**Planning Commission Meeting Agenda**

Tuesday, June 4, 2019, 5:30 PM

**2019 - Class C Single Family Development Staff Report**

**Subject:** Collins Residence  
(Class B Major, Preliminary Hearing; PL-2019-0068)

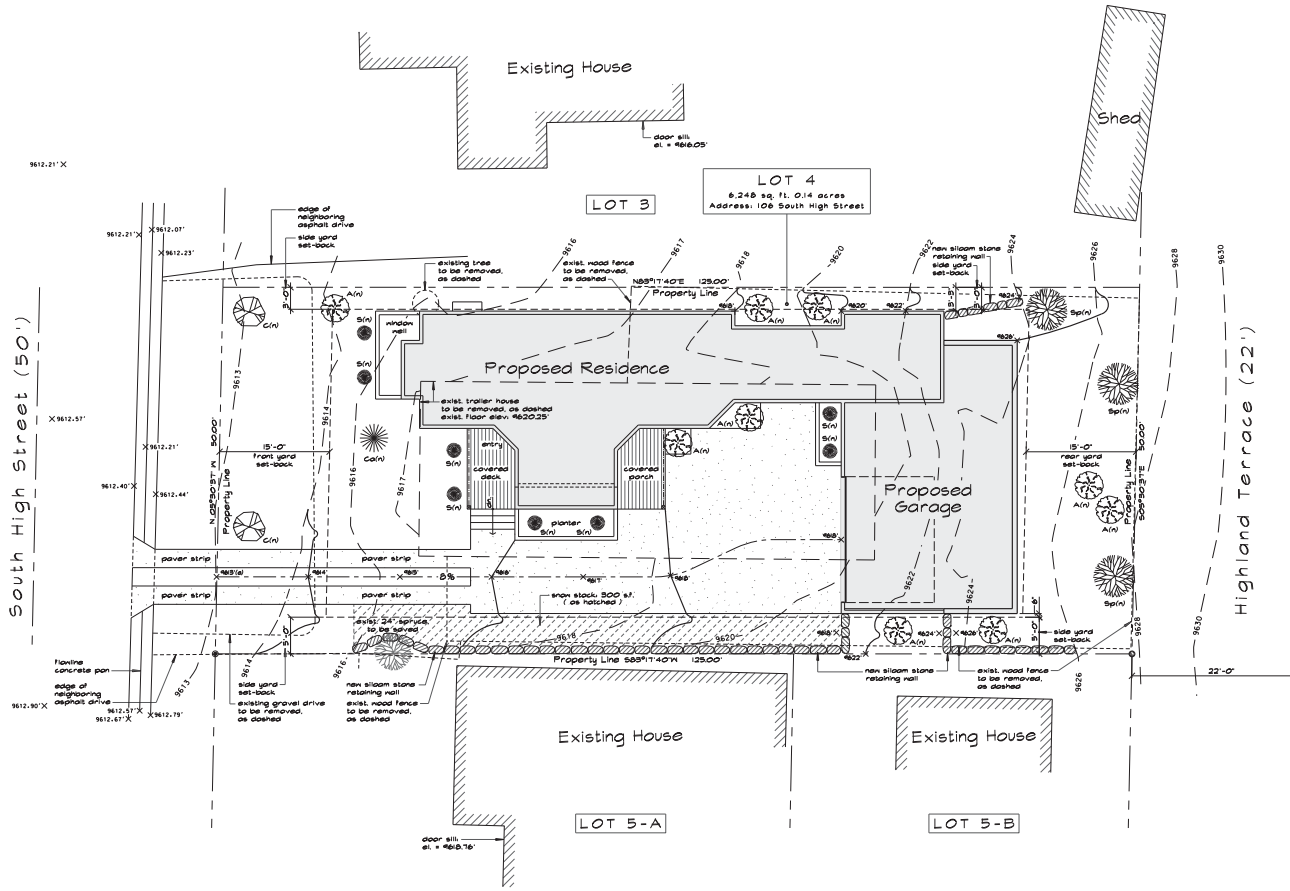
Based on staff's recommendations, we have the following questions for the Commission:

1. **Roof Design** - Staff believes the rear module's roof design should be simplified into a more reminiscent roof style from the 19<sup>th</sup> century to better meet Priority Design Standard 121. Does the Commission Agree?

2. **Windows and Doors** - Staff recommends a reduction of glazing to the two square windows in the eave on the west façade of the front house, the horizontally oriented windows in the eave of the main house's north side, the horizontally oriented windows in the east eave of the rear house and the French Doors on the connector and rear house to comply with Design Standards 91, 95, 96, 128. Does the Commission support this recommendation?

The Planning Department recommends this proposal return for a second review.

**Site Plan, Landscape Plan**  
Scale 1/8" = 1'-0"

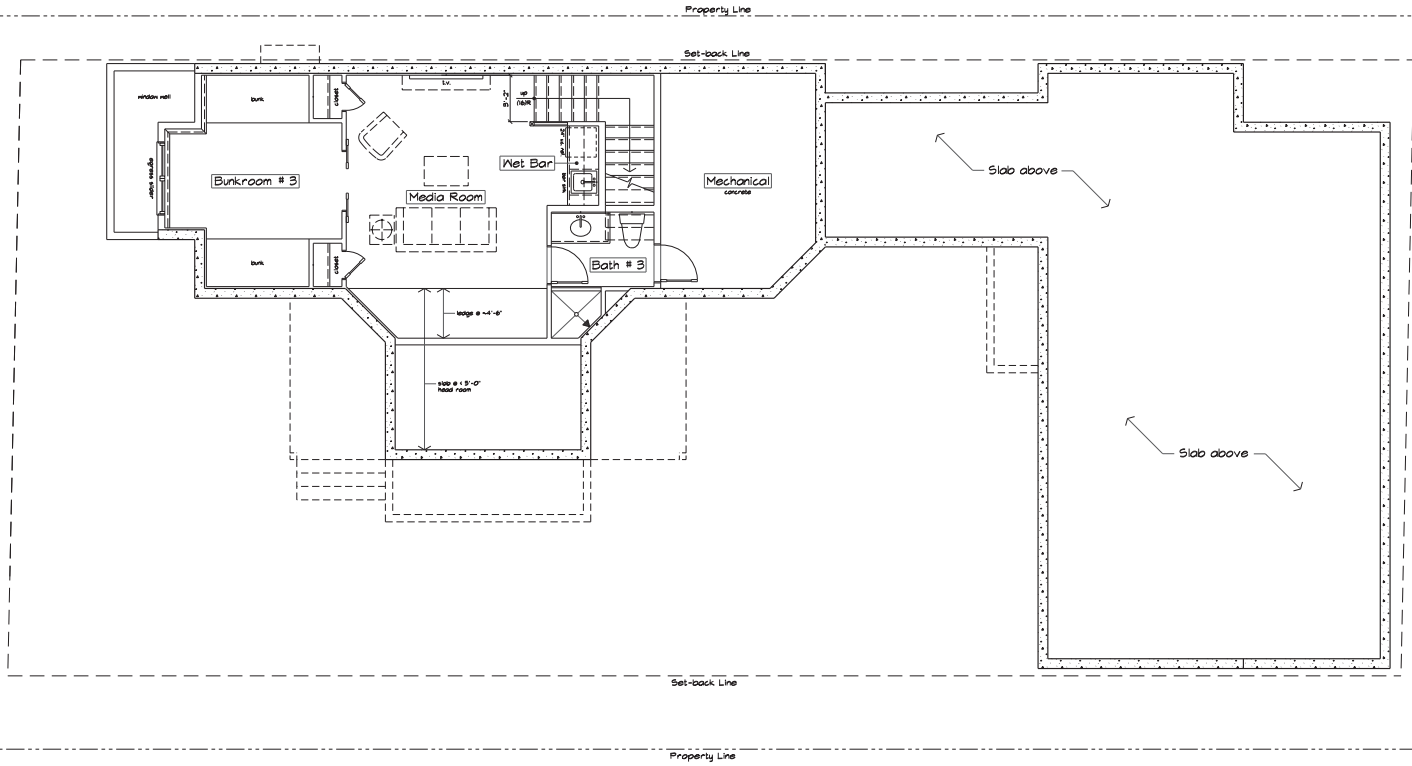
**Site Plan:** The project follows the historic settlement pattern for this block (Priority Design Standard 4). It also matches the Town grid (Priority Design Standard 5). Staff believes that this new construction reinforces the unity of the block (Priority Design Standard 8). All parking is located at the rear of the lot accessed from the High Street via a driveway located on the side of the house (discussion below).

The plans show one existing 24” spruce tree, two new 2.5” cottonwood trees and one new 2.5” spring snow crab apple tree in the front yard (South High Street.). Additionally, the plan proposes a total of nine, 2.5” aspen trees that are planted around the perimeter of the property which gives the plan a solid landscaping plan. Staff does not believe any positive or negative points are warranted.

The drawings show the building exceeds the front yard setback at 24.5', with an additional 8.5' to the roadway. The south side yard and rear setback is met at 5.5' and 15.5' respectively. The north side
